Final Draft Engineering Project Report Update

Central and Eastern Corridor Options
November 2023

Delta Conveyance Final Draft Engineering Project Report Update – Central and Eastern Corridor Options

Reference no.: EDM_PW_CE_RPT_C-E-EPR-Update_001274_V01_FD_20231130

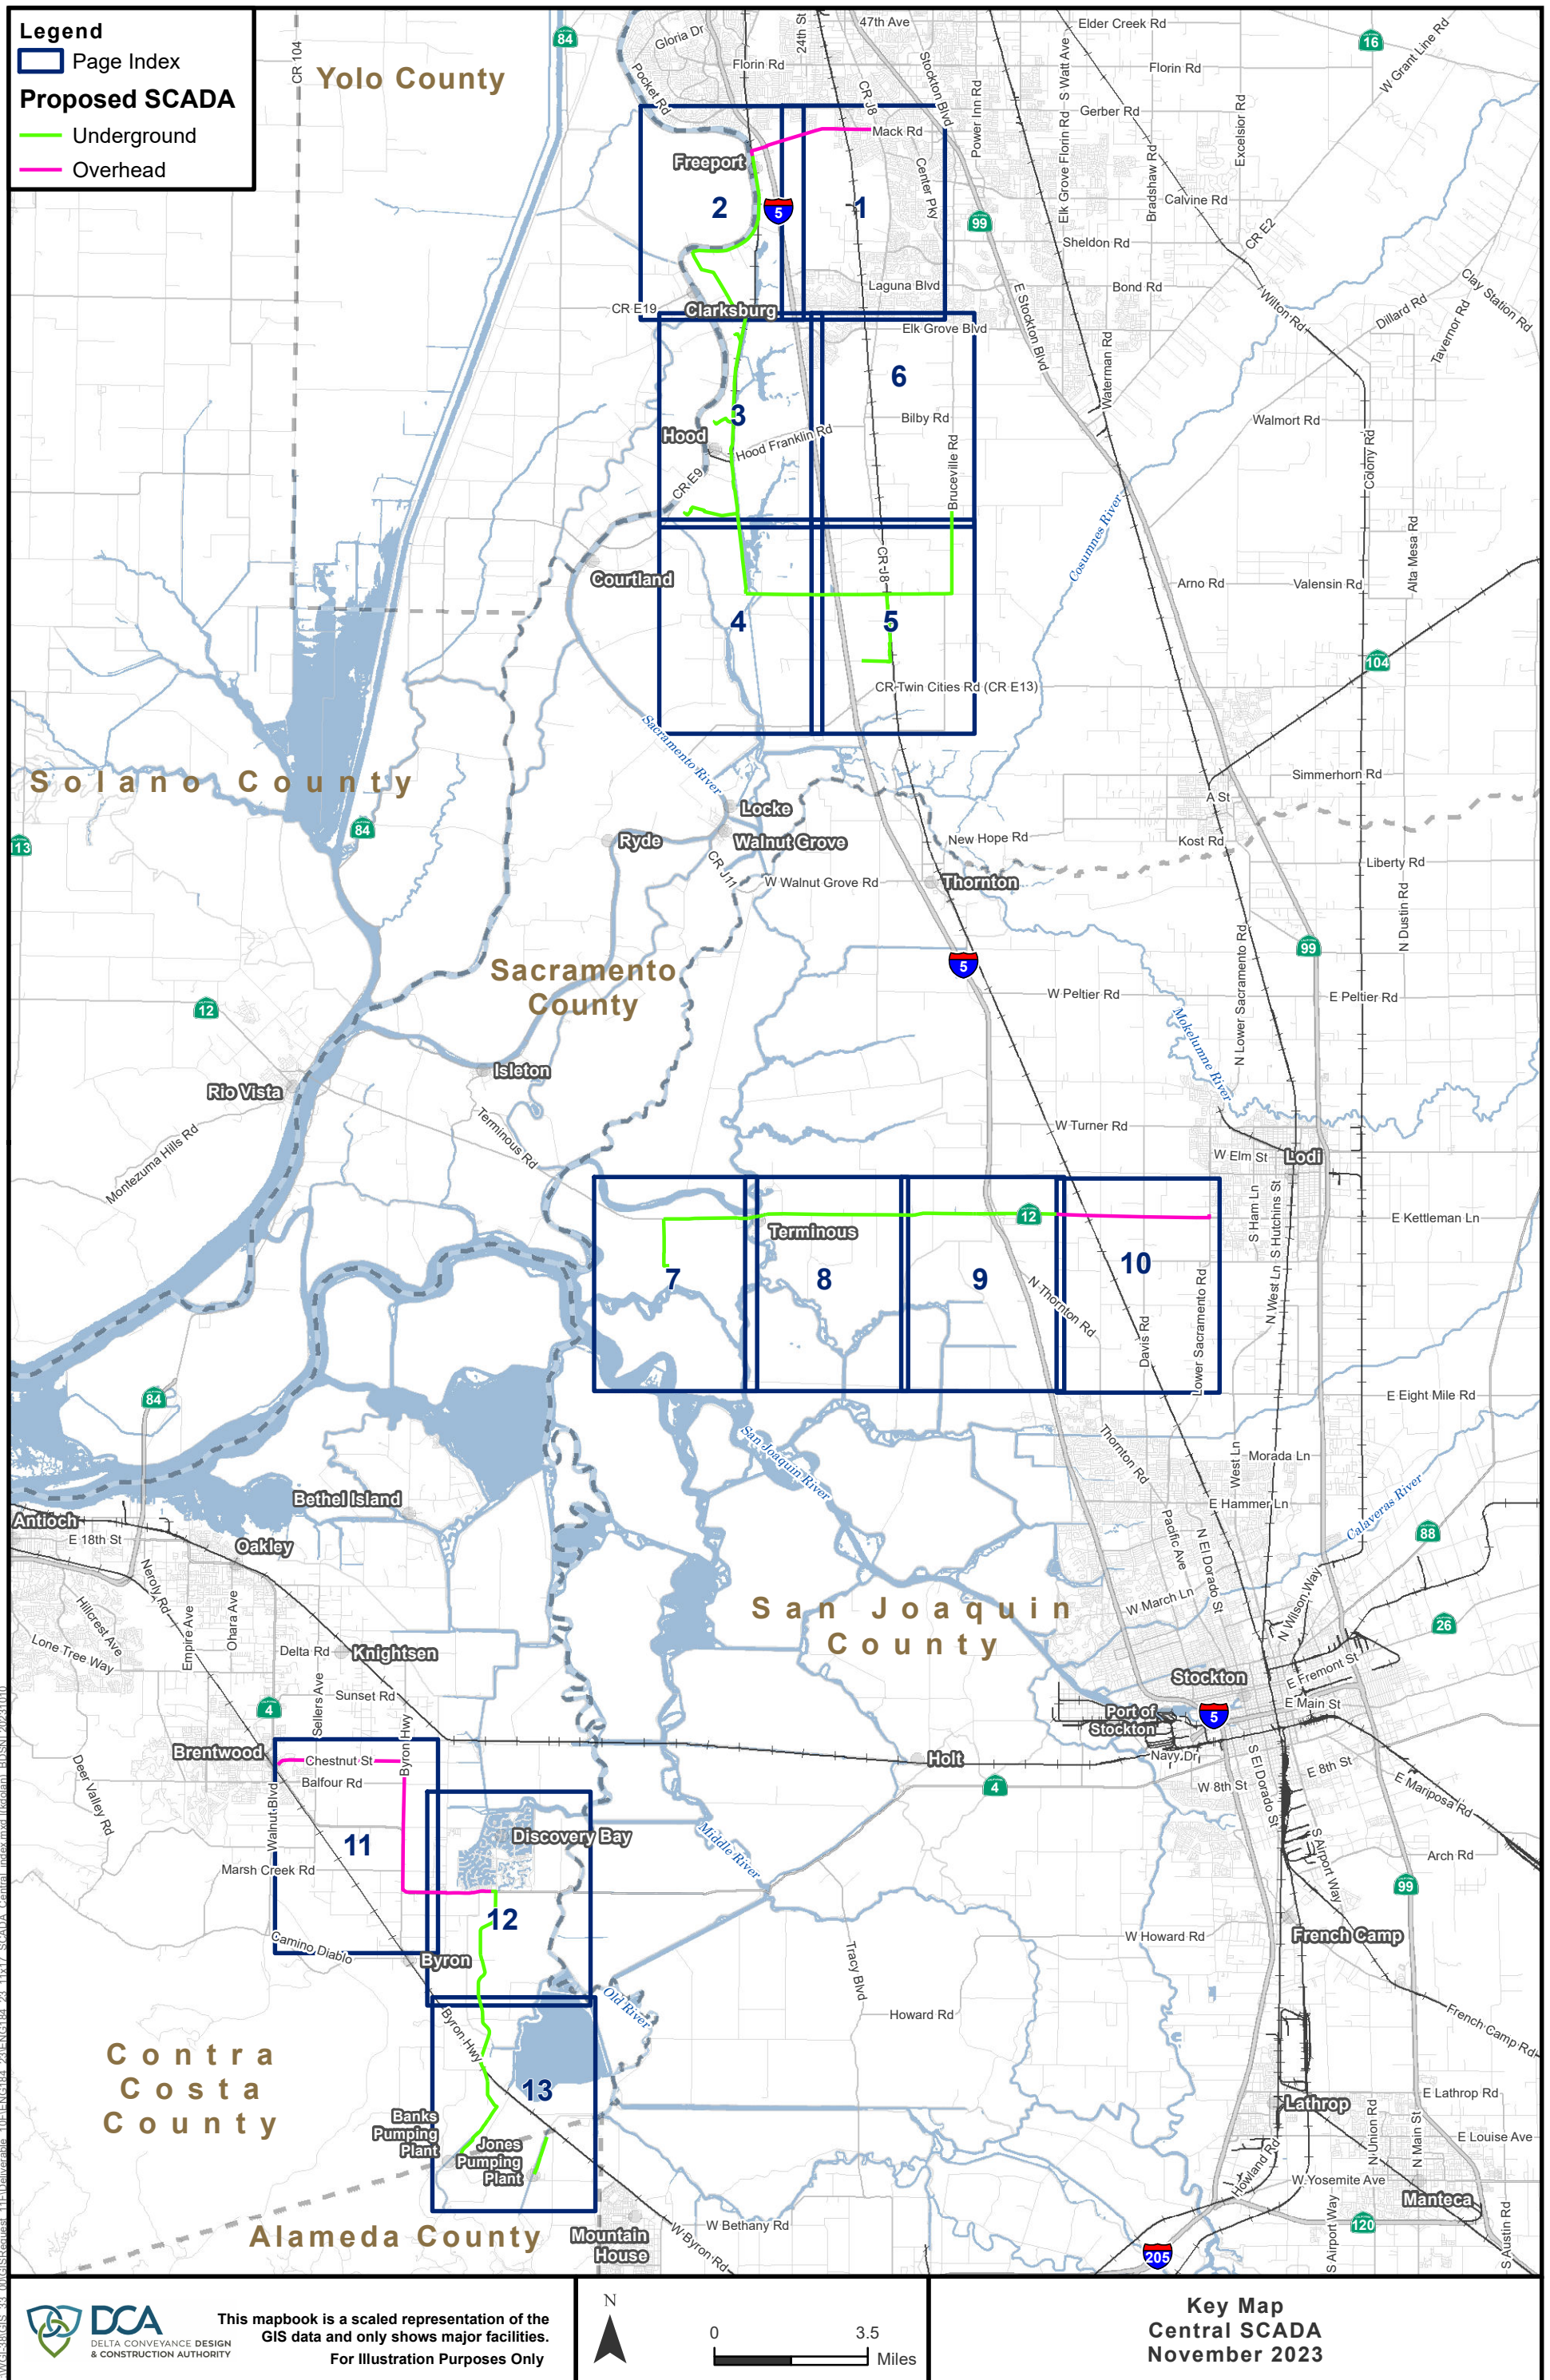
SCADA/Communications Routing and Basin Design Approach – Central and Eastern Corridors TM Attachment 3, Central Corridor Route Maps, has been revised. The key map, and maps 2 and 3 (May 2022 C/E EPR SCADA/Communications Routing and Basin Design Approach TM PDF pages 23, 25 and 26, respectively) have been updated and are included in the Mapbooks section of this EPR Update.

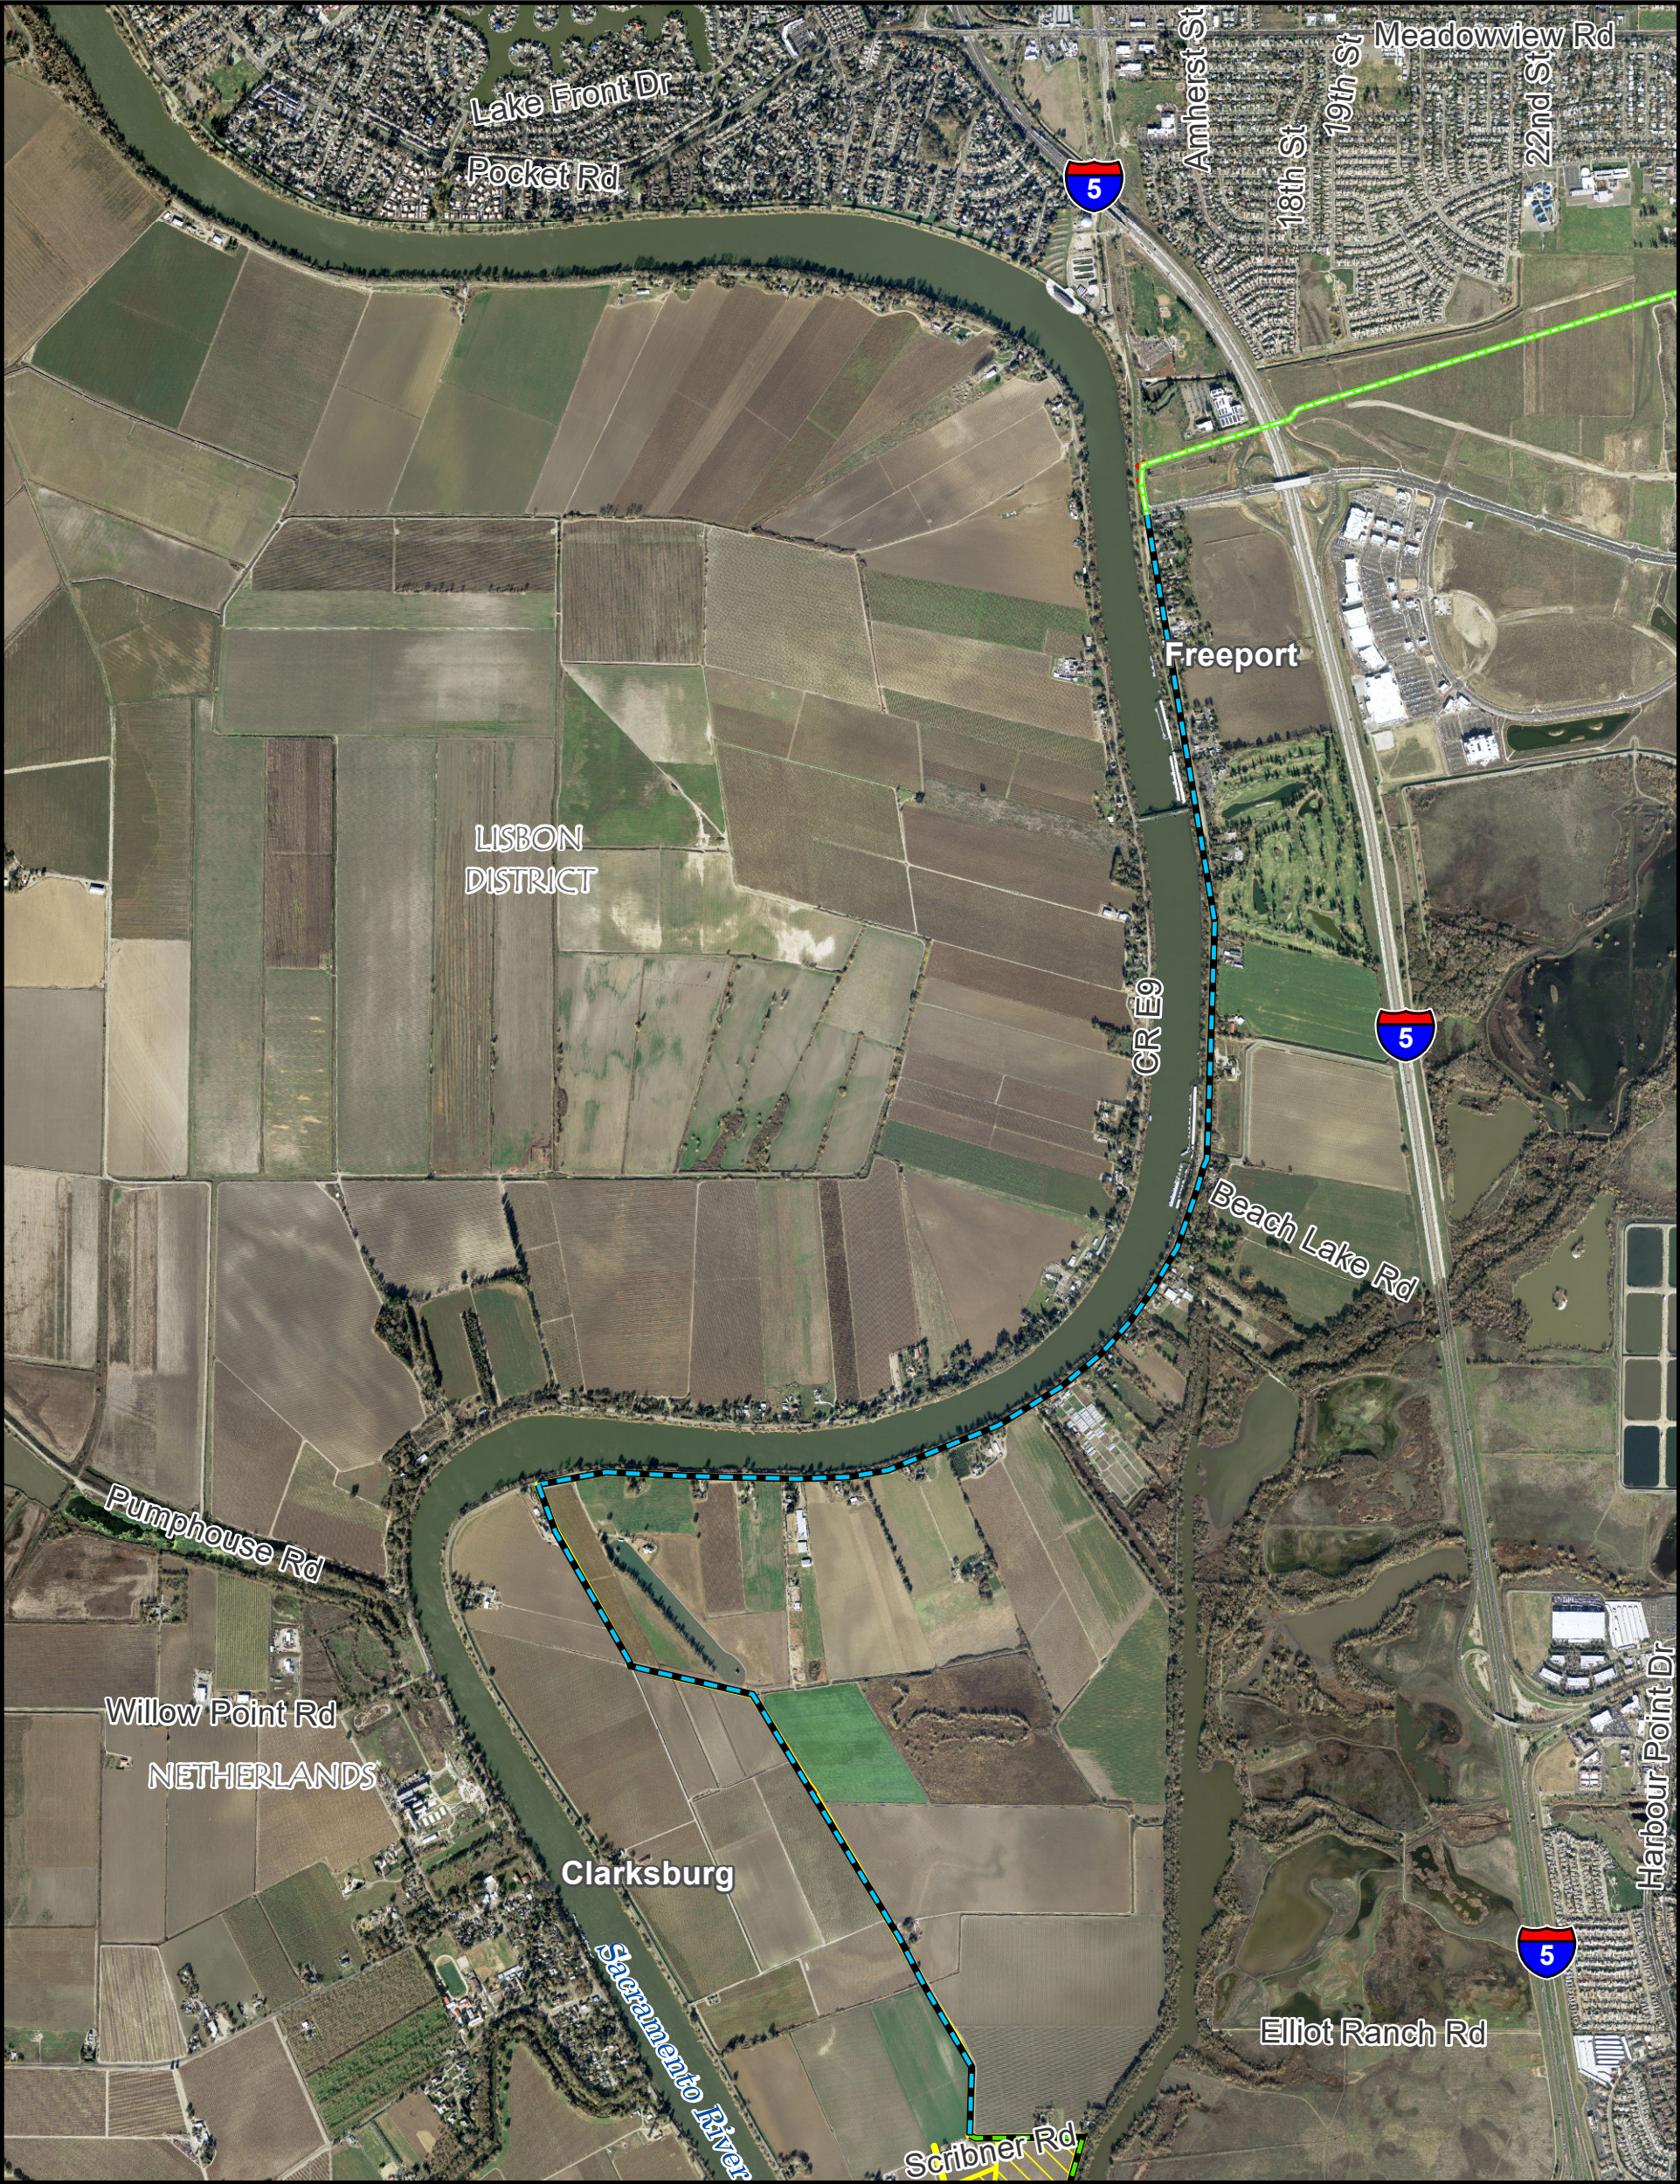
SCADA/Communications Routing and Basin Design Approach – Central and Eastern Corridors TM Attachment 4, Eastern Corridor Route Maps, has been revised. The key map, and maps 2 and 3 (May 2022 C/E EPR SCADA/Communications Routing and Basin Design Approach TM PDF pages 38, 40 and 41, respectively) have been updated and are included in the Mapbooks section of this EPR Update.
